ADDENDUM No. 1

REQUEST FOR QUOTATION No.: 1220-040-2023-075

TITLE: NORTH BLUFF PUMP STATION: PUMP REPLACEMENT

CITY OF SURREY	
TITLE: STRUCTURAL CONCRETE & MASONRY (SHEET 1)	
SCALE: HOR. VER.	SURREY PROJECT NO. MS 4793-324-03
CHECKED: P.W. P.U.	S-135-210(P)
SCALE AS SHOWN	
DRAWING No. 471-005	
SHEET 12 OF 40 ISSUE B

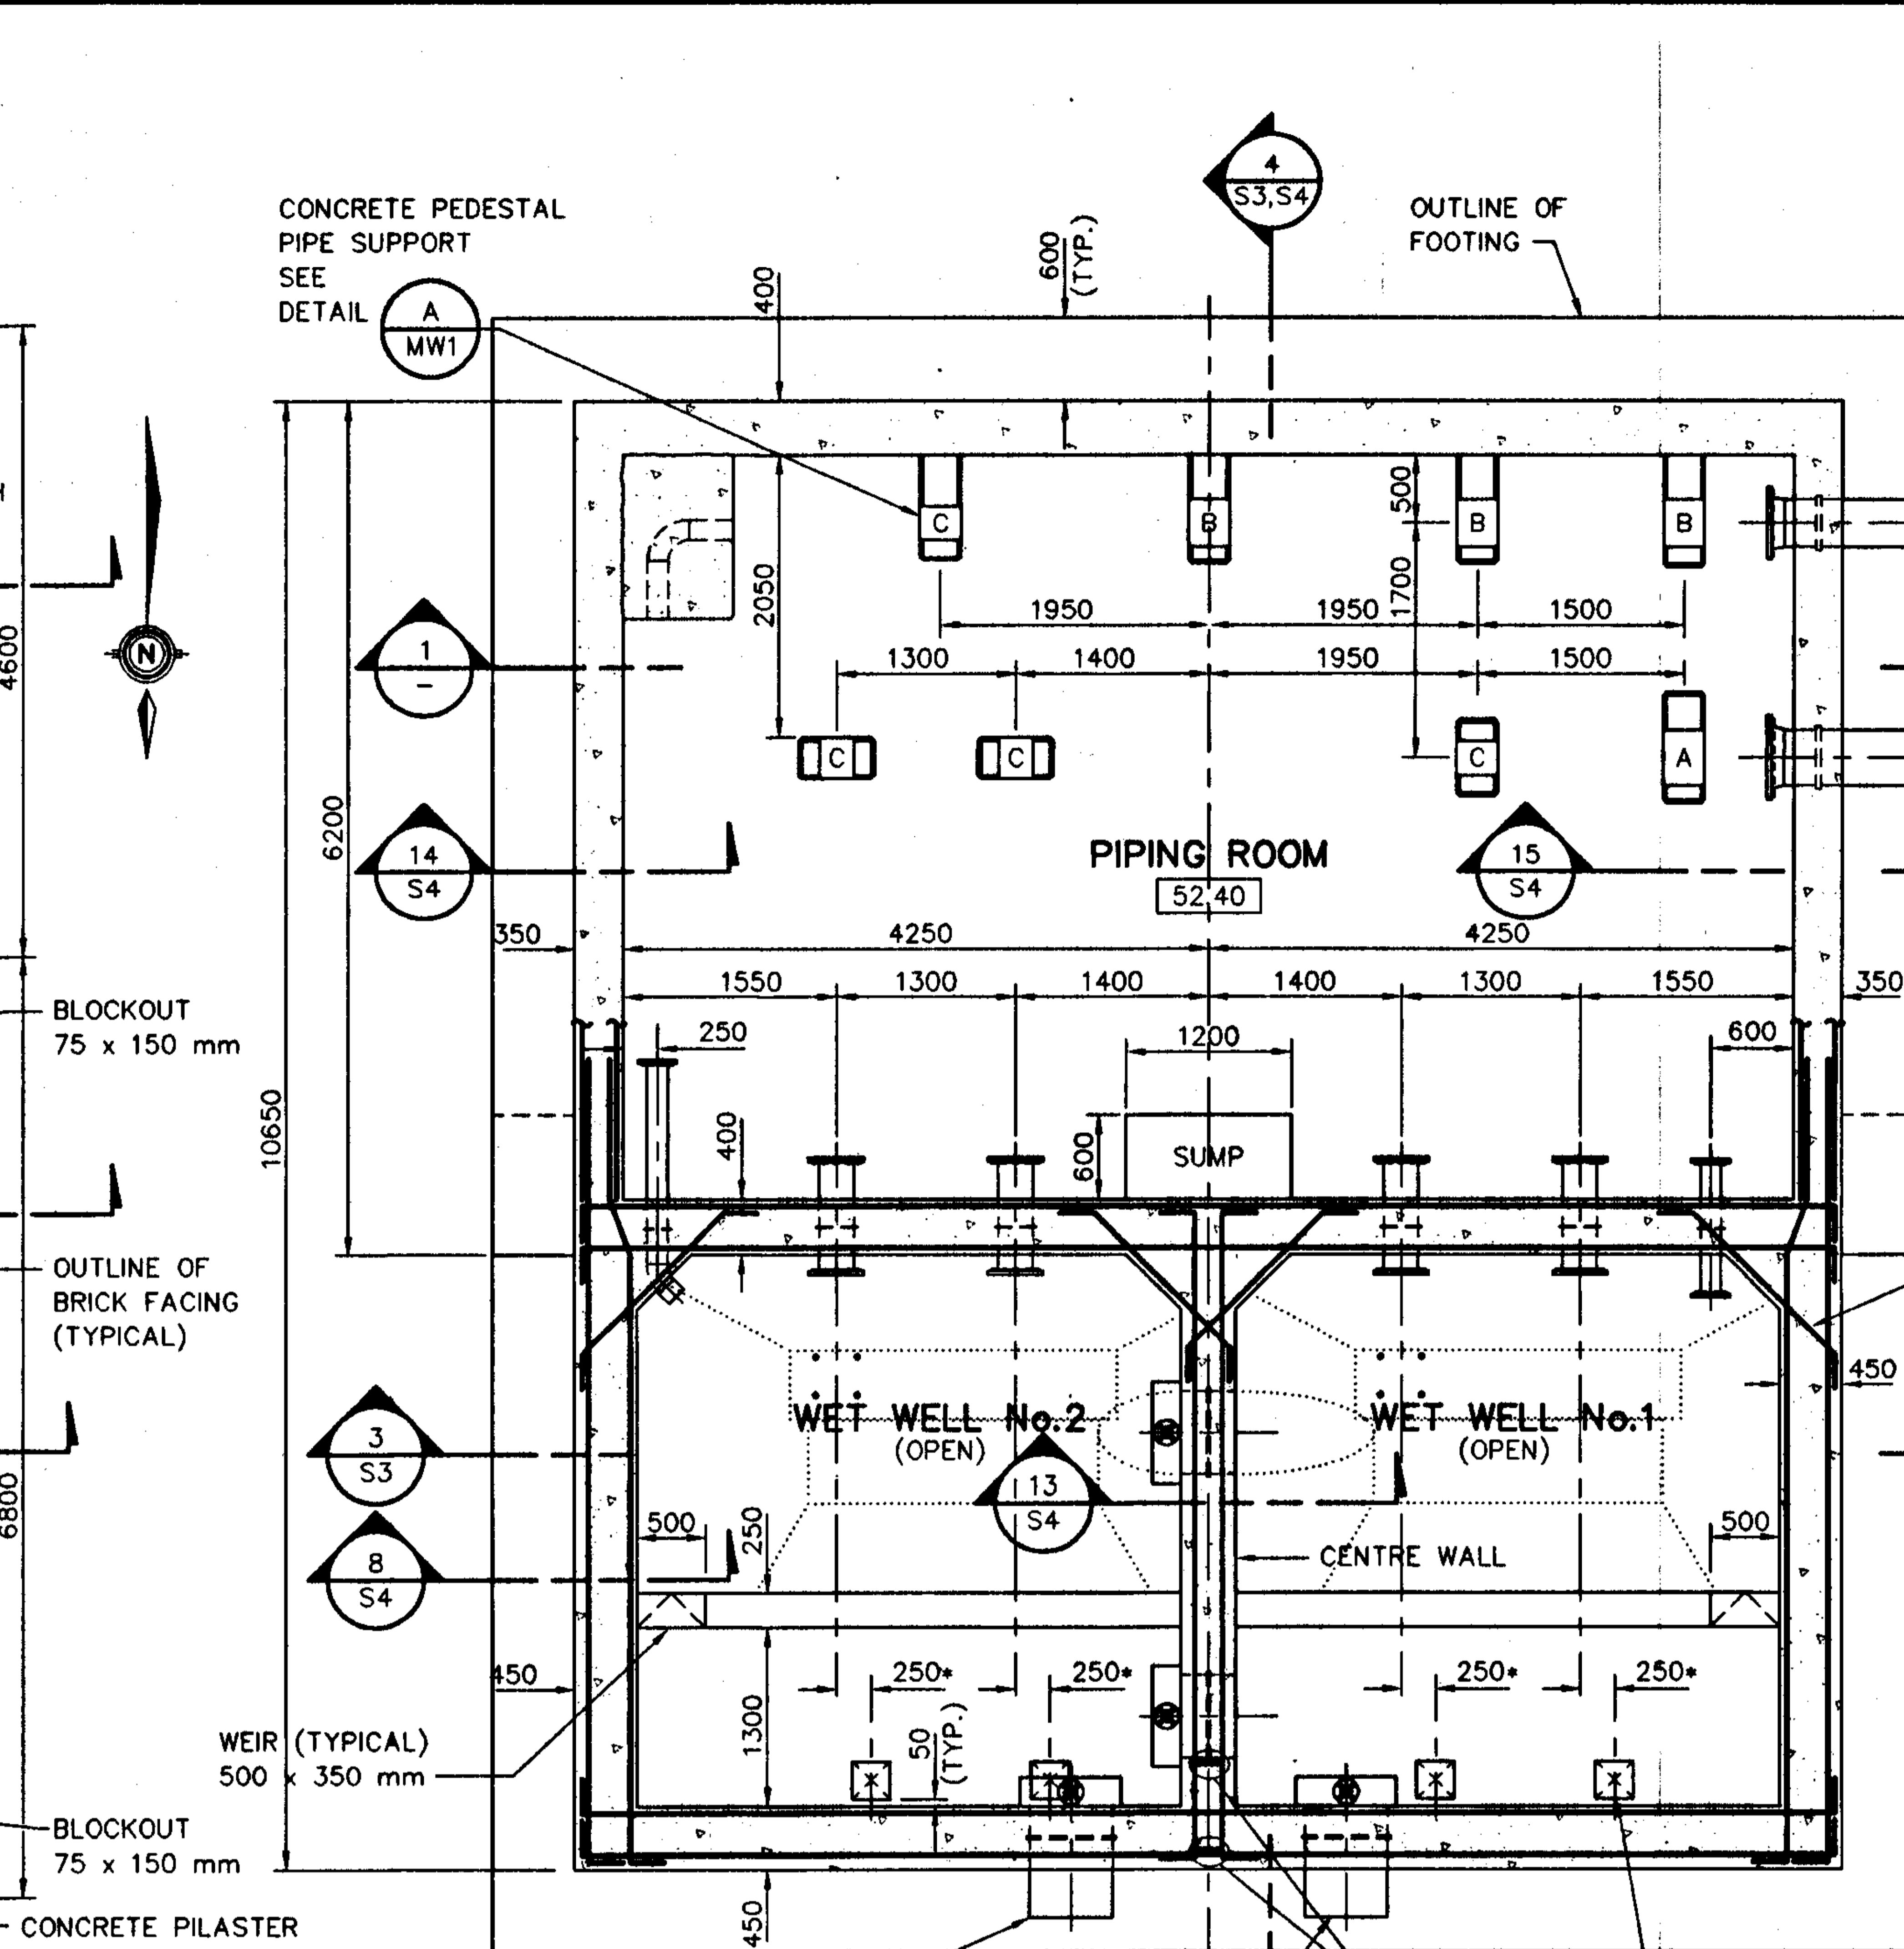
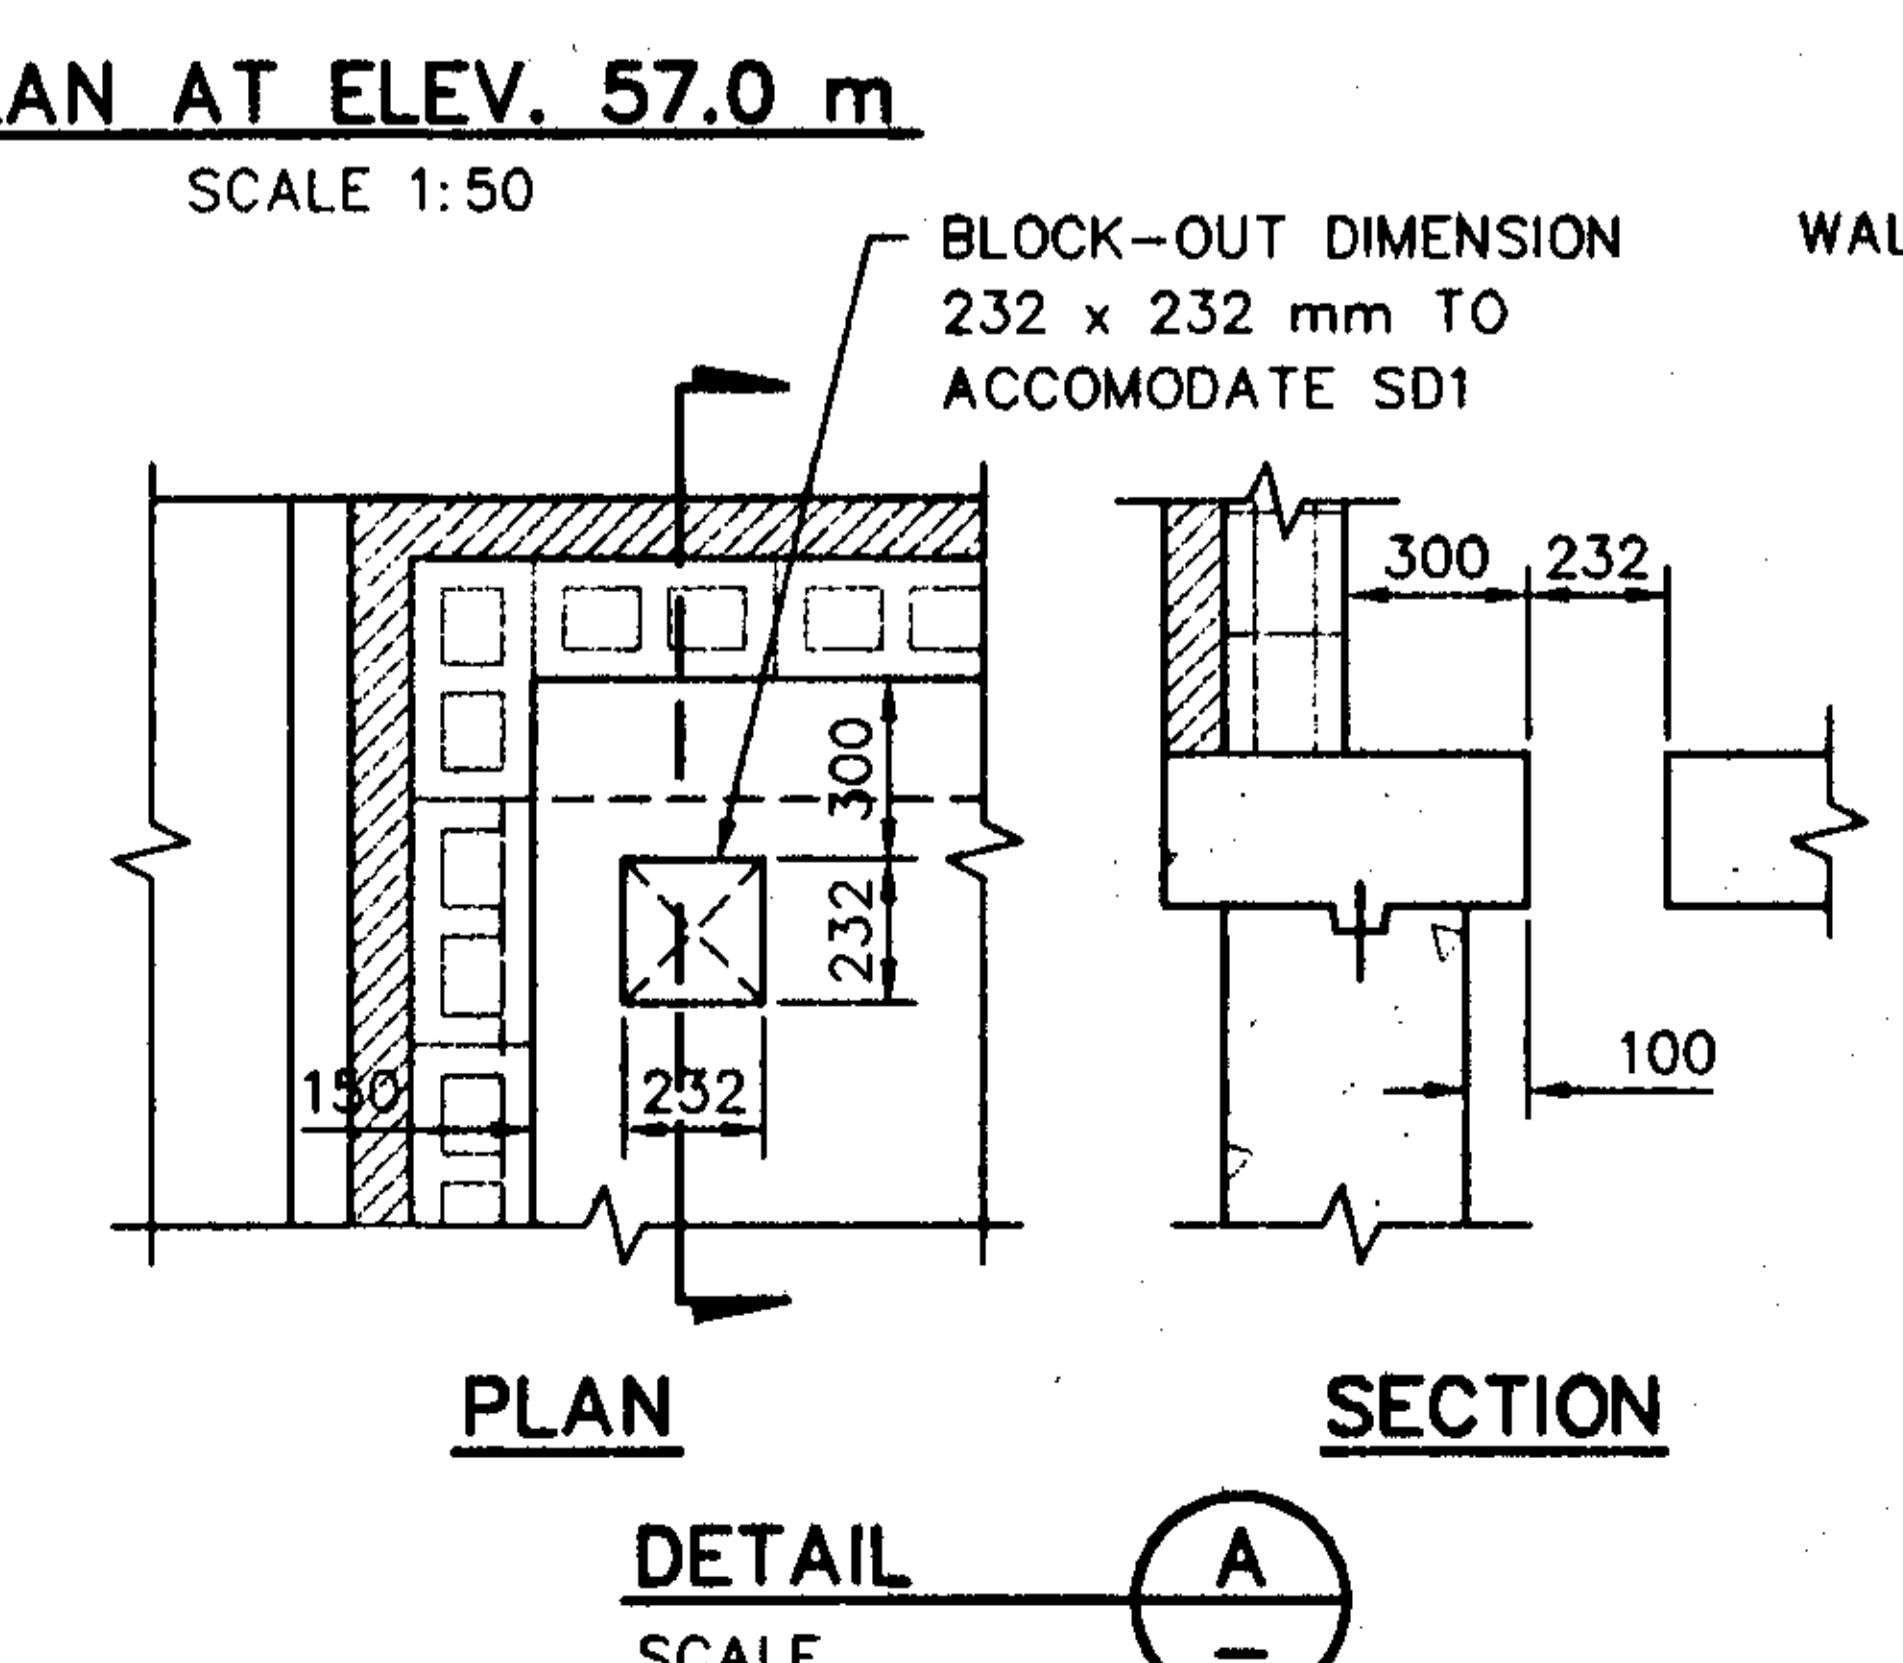
- Q6.** Please provide the hatch dimensions shown on the drawing S-135-205 (P).
- A6.** Actual opening is 42" x 42". The guide rails may not be compatible with all the pumps. If they have to be modified, it could affect the opening available space for installing/ removing the pumps. See Attachment No. 1 – Structural Concrete & Masonry on page 5 for additional information.
